ADDENDUM NUMBER 1 – February 27, 2019
SPECIFICATIONS / DRAWINGS DATED DECEMBER 3, 2018

ROOF REPLACEMENT AND WALL REHABILITATION

**ATLANTIC CITY MUNICIPAL UTILITIES AUTHORITY BUILDING
(ACMUA)
401 NORTH VIRGINIA AVENUE
ATLANTIC CITY, NJ 08401**

REMUS ARCHITECTURE, LLC. REFERENCE #18-122

ROOF REPLACEMENT & WALL PANEL REHABILITATION
 for ATLANTIC CITY M.J.A - 401 North Virginia Ave, PO BOX 117, Atlantic City, NJ 08404
 WIND UPLIFT PRESSURES PLAN - SCALE: NOT TO SCALE

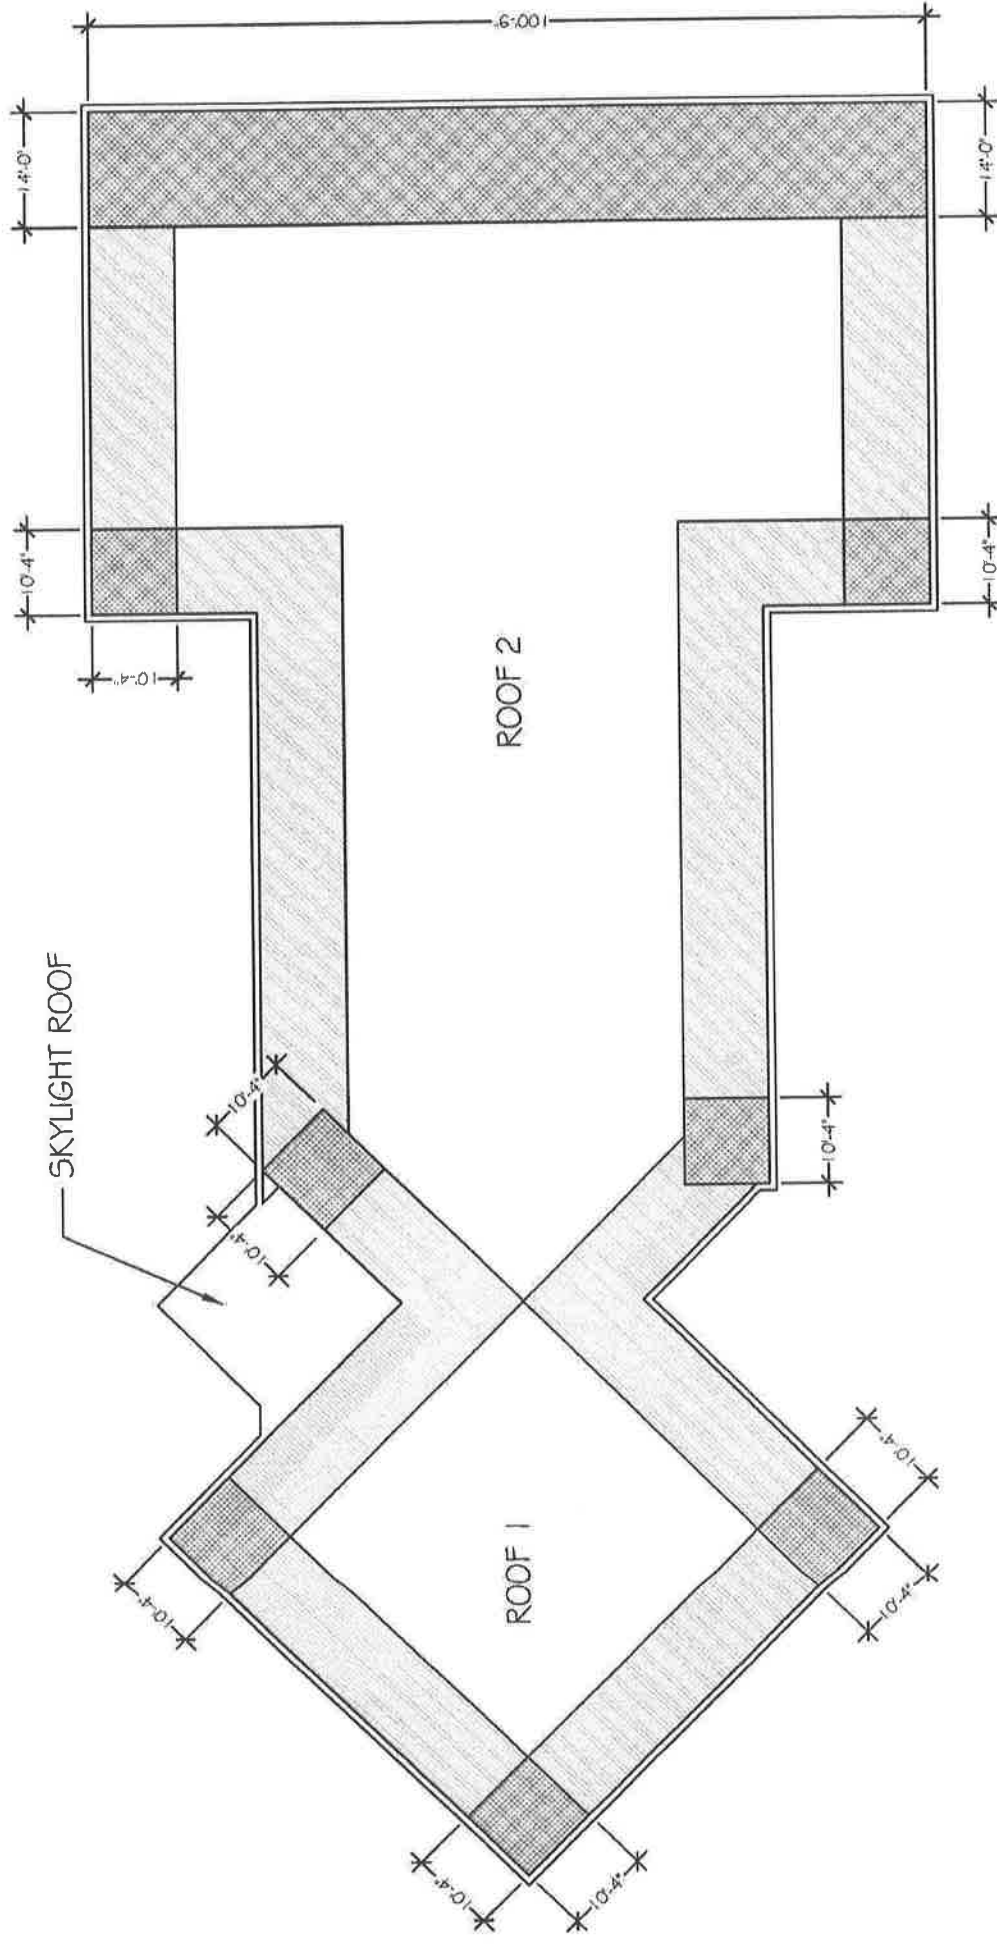
Q2. What are the calculated uplift pressures for the roof?

A2. Attached to this Addendum is a Key Plan outlining wind uplift pressures to be utilized to determine roof system attachment requirements by the intended roof system manufacturer.

UPLIFT PRESSURES KEY

- ZONE 1 - 45 PSF
- ZONE 2 - 55 PSF
- ZONE 3 - 55 PSF
